December 16, 2016

PRODUCT CHANGE ANNOUNCEMENT

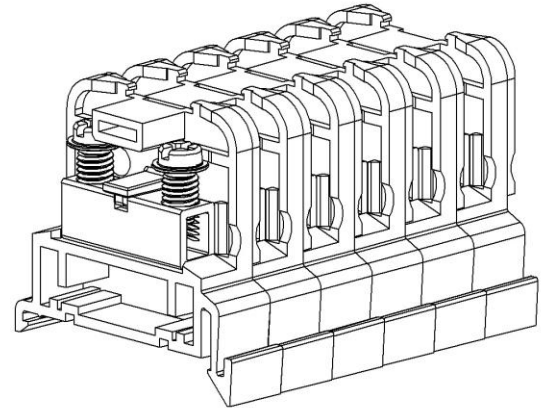
Marathon Special Products is enhancing the drive feature of the screw for our 6G38 products. The new screw adds a Phillips drive feature to the slotted drive feature, which will enable a slotted, Phillips #2, or terminal block screwdriver to be used while tightening. The current screw is a washer head screw with only a slotted drive feature.

This will be a running change and will take place on or around Jan 30, 2017, therefore, all products built from approximately Feb. 1, 2017 forward will include the re-designed screw. If your inventory should contain both the new and old screw, the same screwdriver for the old will also work on the new, since they are both capable of accepting a slotted drive.
